*Revision updating drainage areas and inlet calculations and utility main alignments

CORLEY FARMS
UNIT 2

CONSTRUCTION PLANS

DRAIN PLAN & PROFILE - DRAIN '2-C'

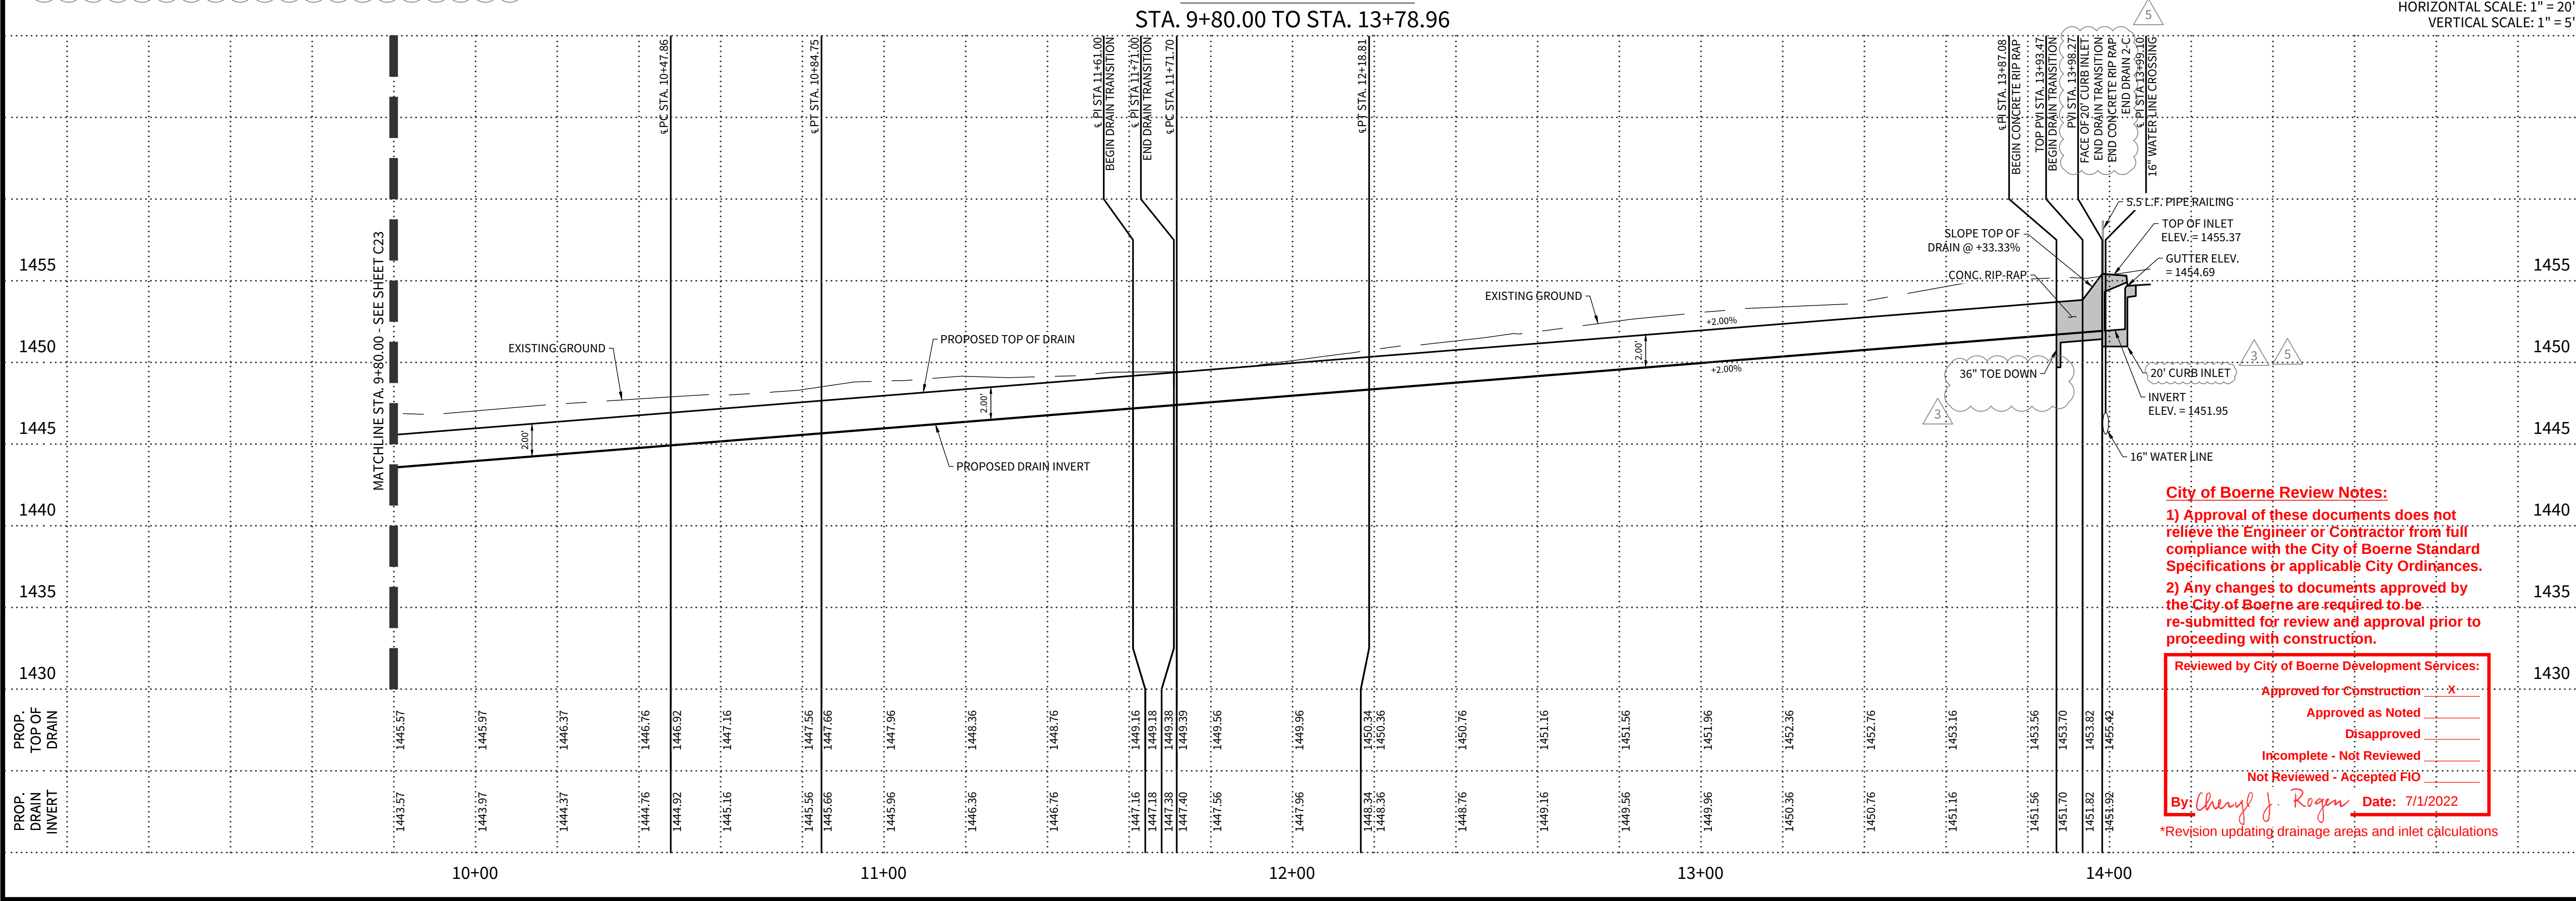
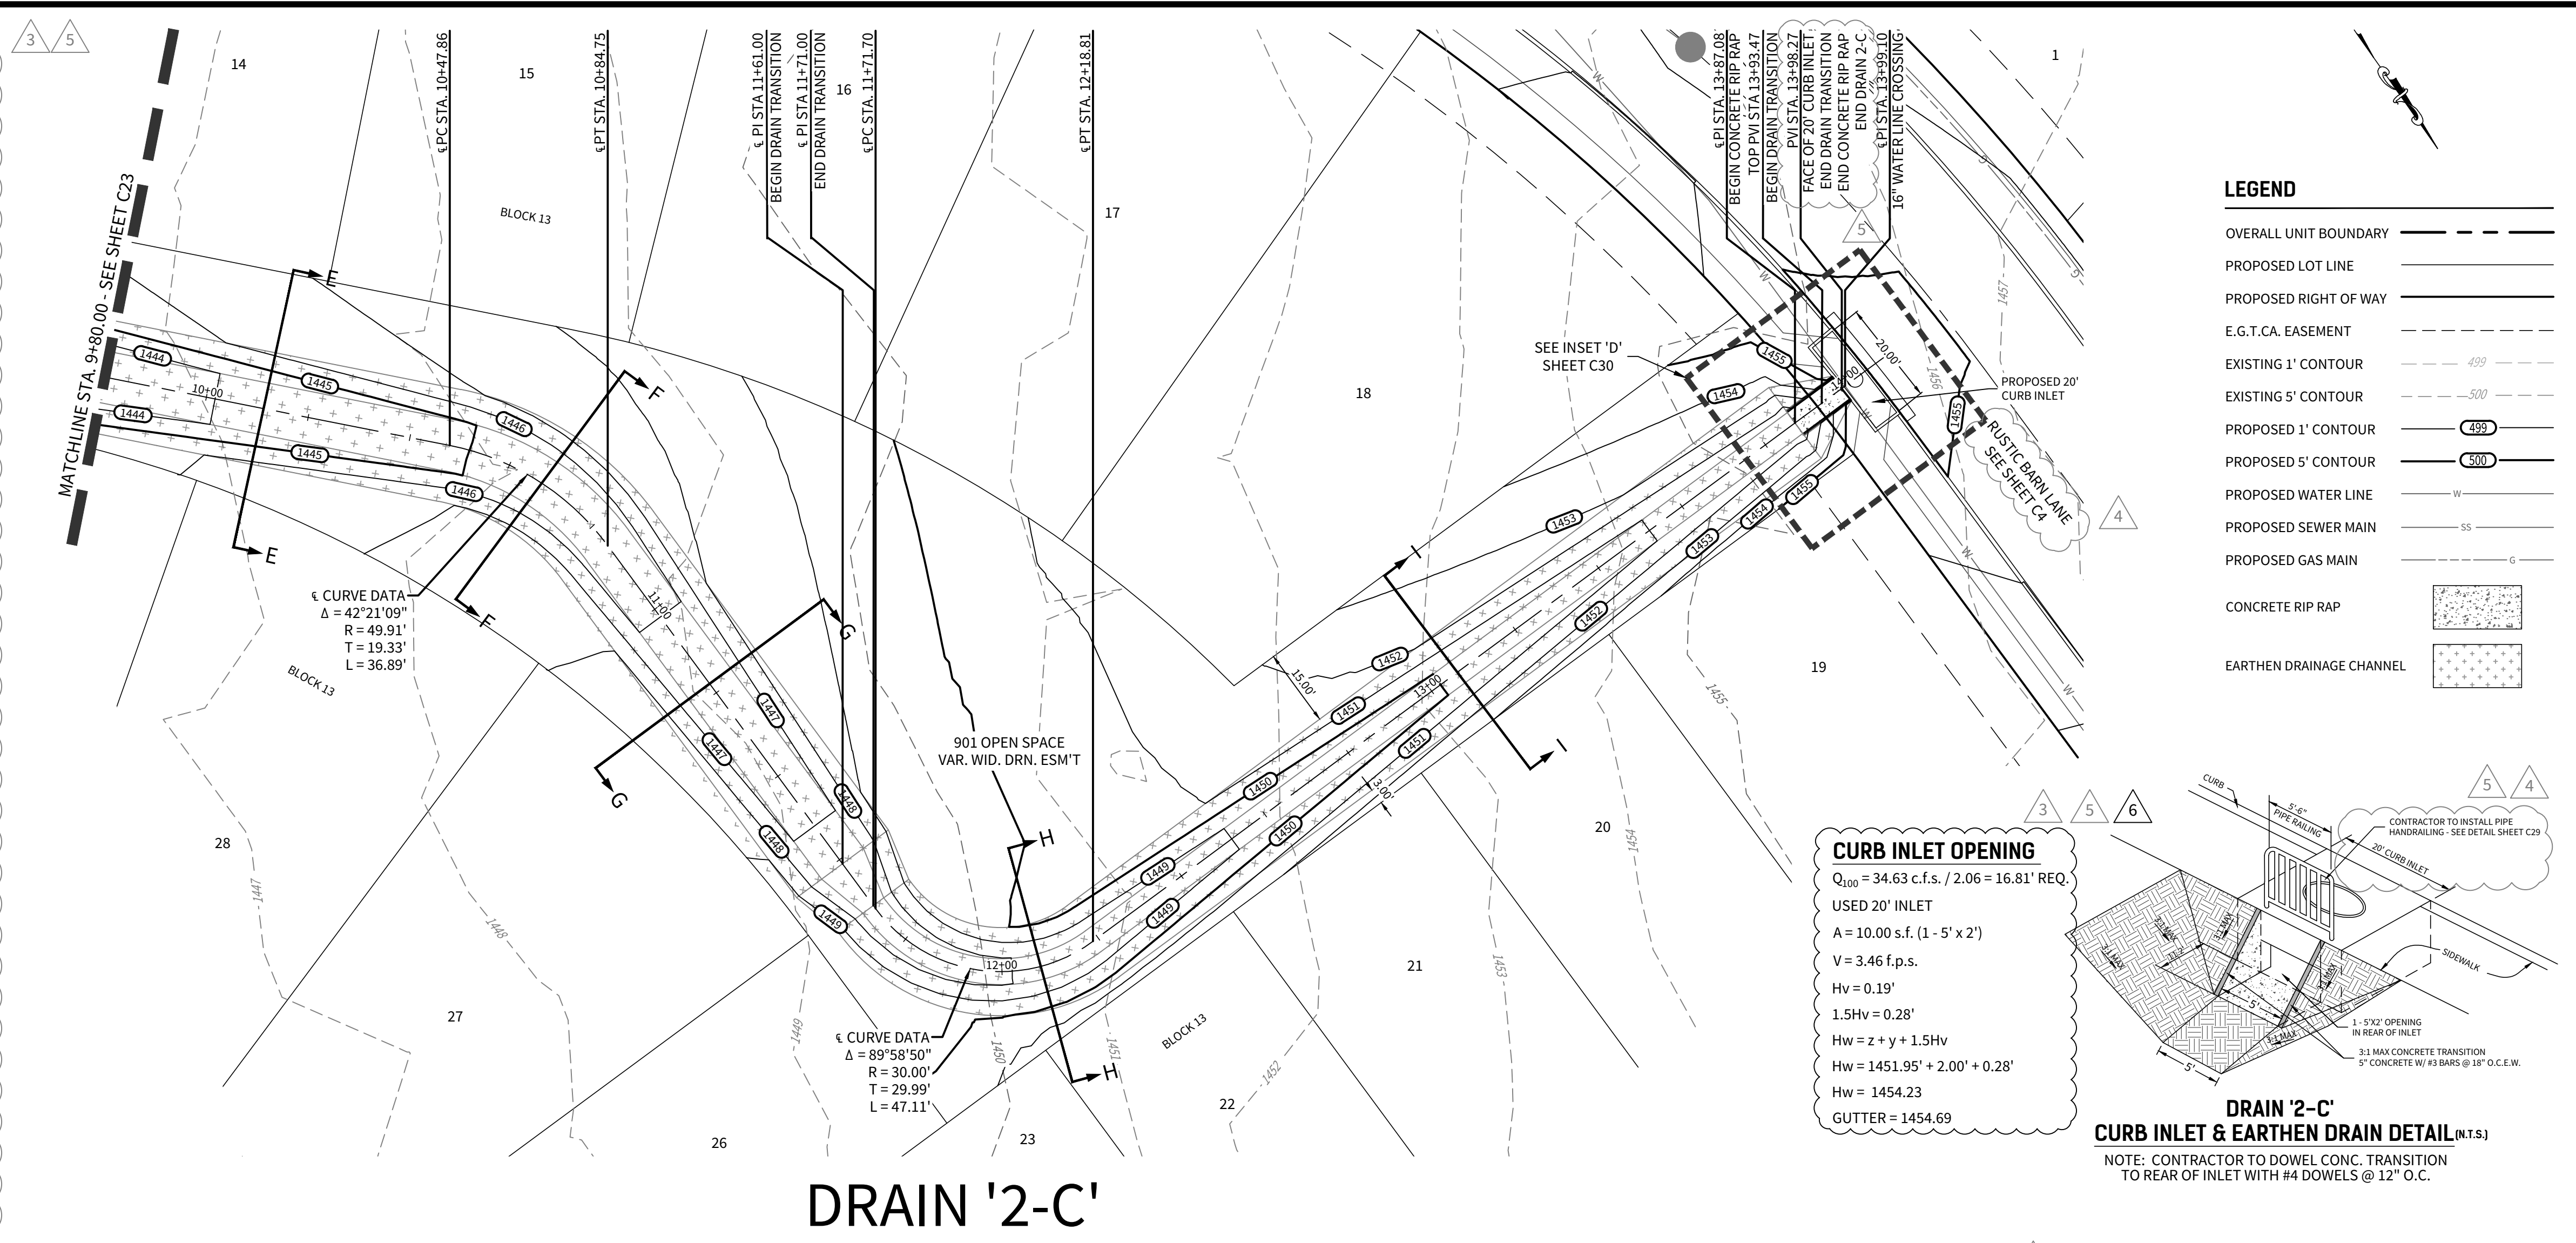
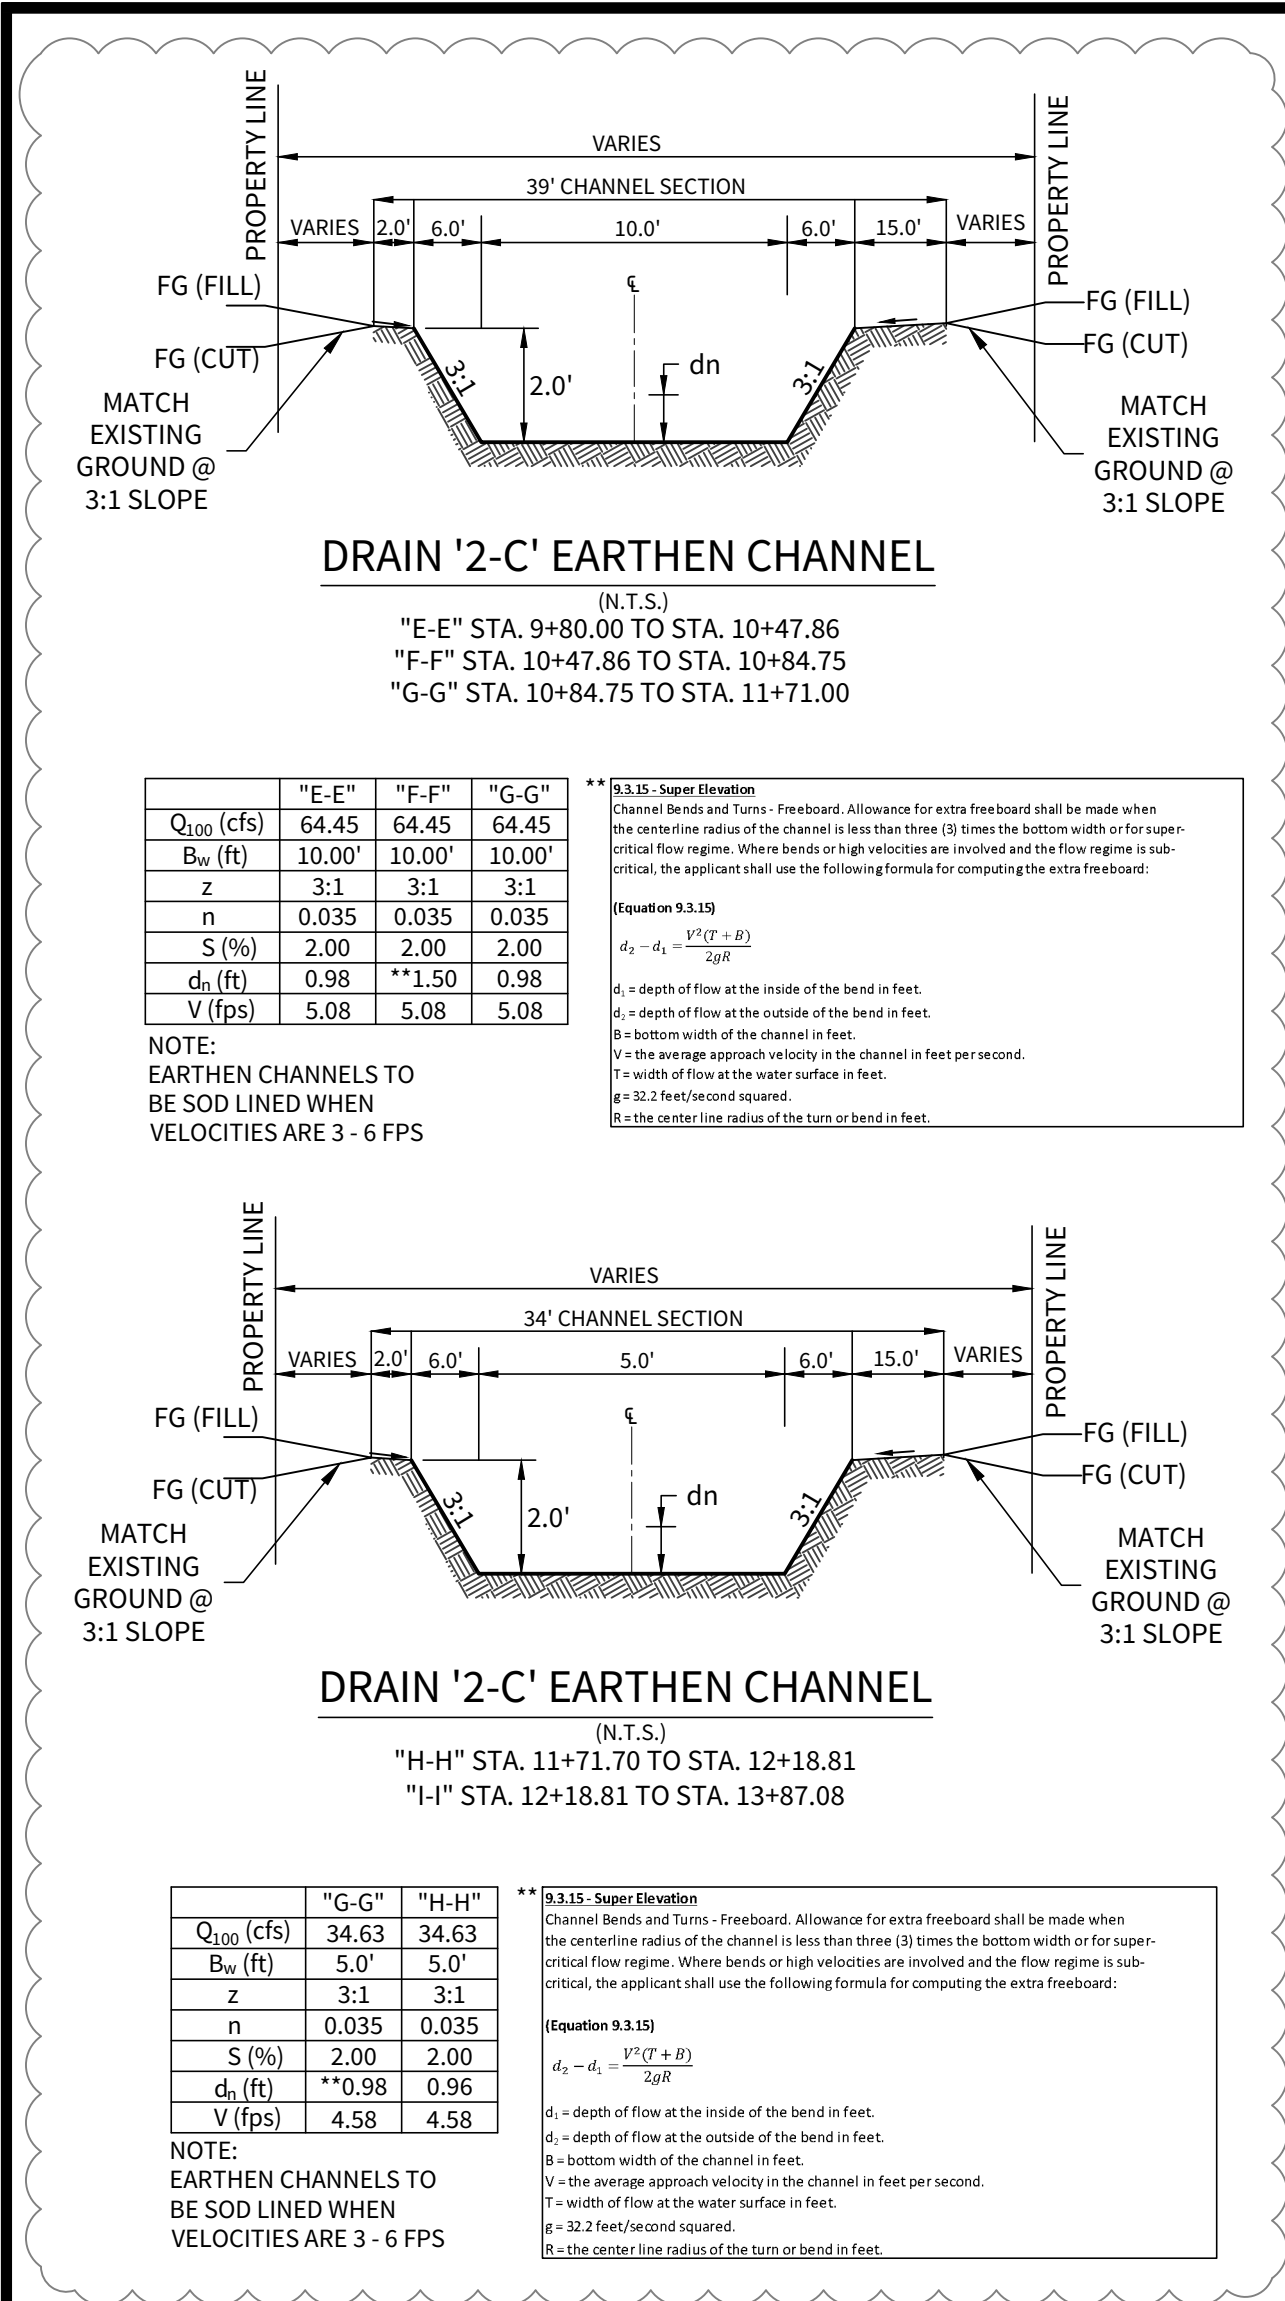
- 2021-06-23 - REVISED CURB INLET VELOCITY.
-
- 2021-10-07 - CITY OF BOERNE COMMENTS
- 2021-11-12 - CITY OF BOERNE COMMENTS
- 2022-03-03 - DRAINAGE UPDATES
- 2022-05-19 - C&B COMMENTS
-
-
-
-

*Revision updating drainage areas and inlet calculations
